G.O., No. 172 M

Hospital Building

Calling for certain information in connection with the ---- at Srivilliputtur.

Municipal hospital at Srivilliputtur

Plan
Hospital & surroundings
...liputtur

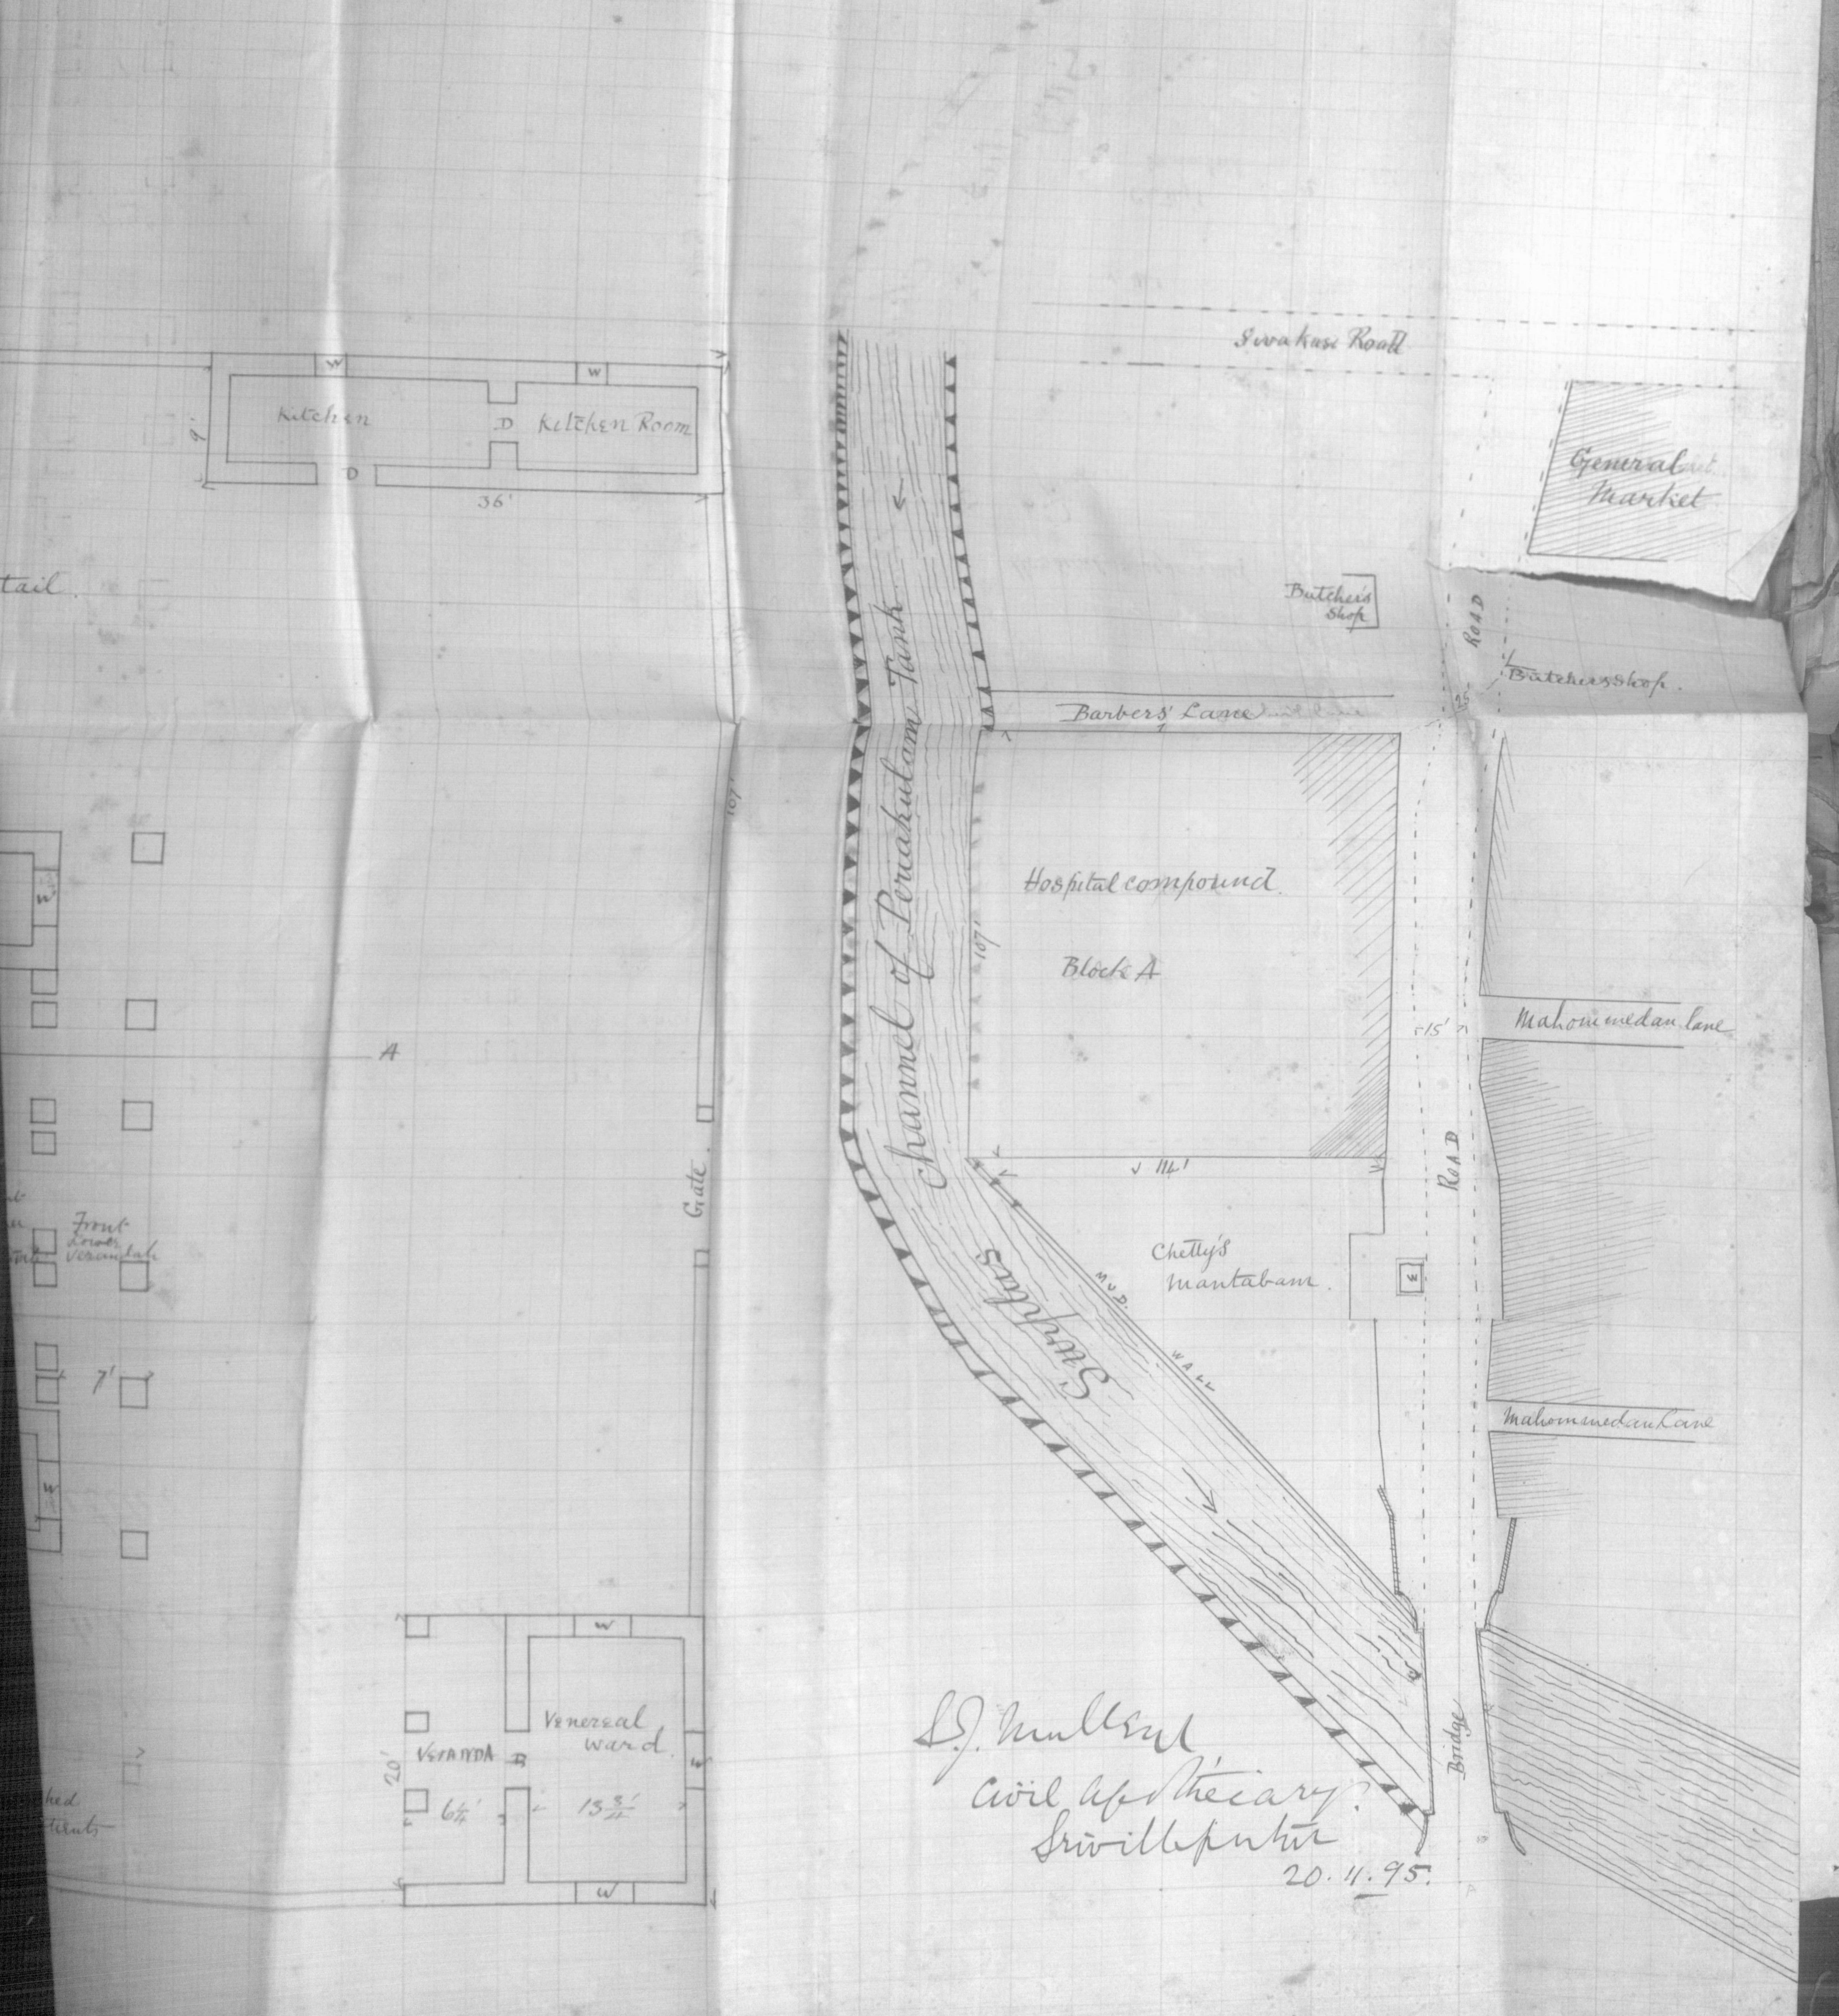
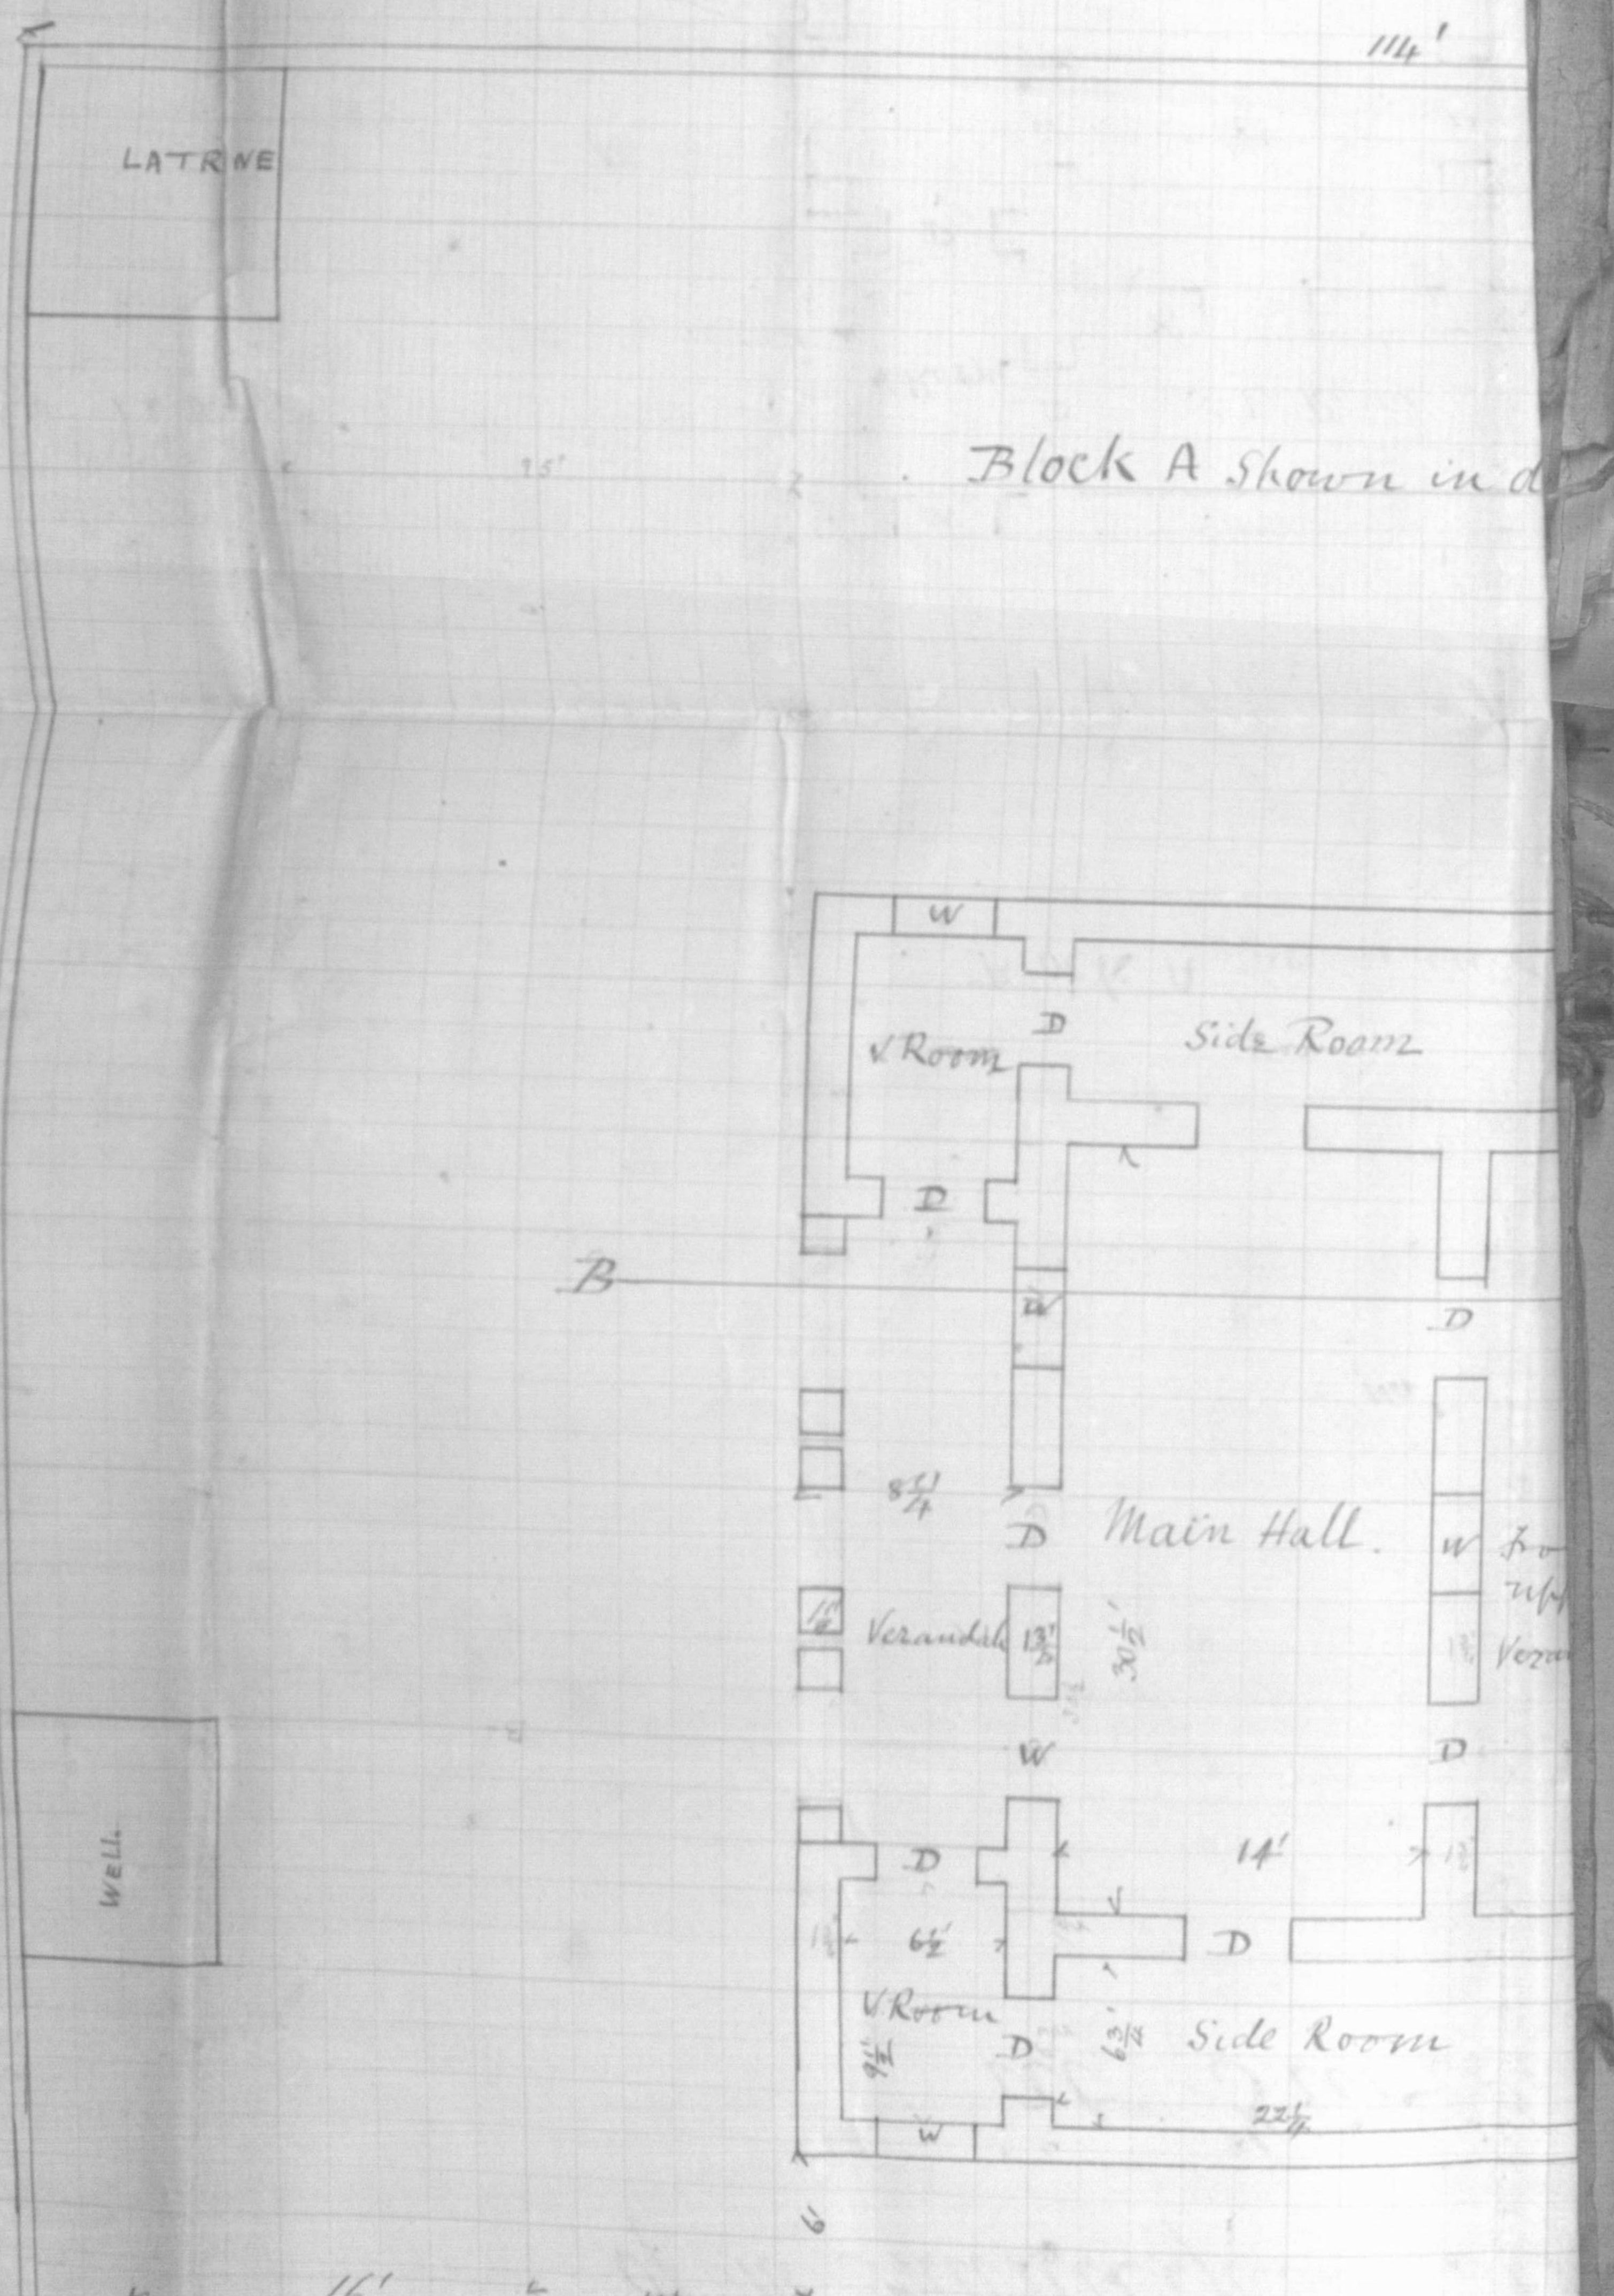
Extent. The hospital compound measures, as shown in the plan, 107 feet from north to south and 114 feet from East to west.

2. Boundaries. The hospital is bounded, in the north by a lane leading to the barbers booths and a number of unsightly barbers huts. Past this there are a few butchers' shops, a Mahommedan Mosque, with burial grounds and the general and fish markets. In the East it is bounded by a road about 15 feet wide joining the Sivakasi road with the north south street of the town

There is another butcher's shop within a distance of 25 feet from the north Eastern End of the hospital and there are a number of unclean Mohommedan huts huddled up to the East of the road and front view of the hospital. The South forms a triangular piece of land bordering on the surplus channel as shown in the plan and having a Mantabam, a place of worship belonging to the Chetties of the town. The West of the hospital Compound is bounded right through by the surplus channel above referred to which is very filthy, the banks of which being largely used by the people for Calls of nature. To the West of the channel, there are crowded houses of Chetties and oil mongers wherefrom the obnoxious smell of the Expressed oils of all sorts mingled with that Emanating from the dried filthy channel is frequently wafted by the westerly wind in and out of season.

of the hospital are altogether unhealthy. The hospital besides being in the midst of unsightly and unclean crowded huts of barbers, Mahommedans and oil-mongers and in close proximity to butchers' shop, fish and general market and Mahommedan burial grounds, is very much shut out from free ventilation and pure air and is situated at the Edge of a filthy channel which is being used as a latrine by the children during the day time and the elderly people in the night time.

4. Accommodation. The hospital, as shown in the plan consists of a main hall, with two verandahs and side rooms and verandahs in front and rear. In the South-Eastern corner of the compound, there is a small hall with a front verandah called "Venereal ward." In the north Eastern corner there is a kitchen and kitchen room, under the same roof. In the South western End of the compound at a distance of only 10 feet from the main building, there is a Post-mortem room. In the north western corner there is a l[illegible] as shown in the plan [illegible]

In conclusion I beg to report that besides the hospital being situated on an unhealthy site with bad and insanitary surroundings and very much shut out, is ill-suited for the purpose of a large hospital which has treated upwards of 26,500 patients this year up to date, as it affords very poor accommodation for In-Patients having no separate wards for male and female patients and no separate dressing rooms for men and women. I beg to add that the compound is too small to accommodate new wards and it is not desirable to have Cholera and other contagious sheds in the midst of the town. Copies of remarks from the visitors' book relating to the hospital [illegible]lding and site are herewith submitted and the proceedings of the Government herewith returned.

2. My opinion is that additional accommodation is required, and that such accommodation cannot be provided on the present site, which, besides being constructed, is unhealthy. I therefore advocate

the construction of a new hospital.
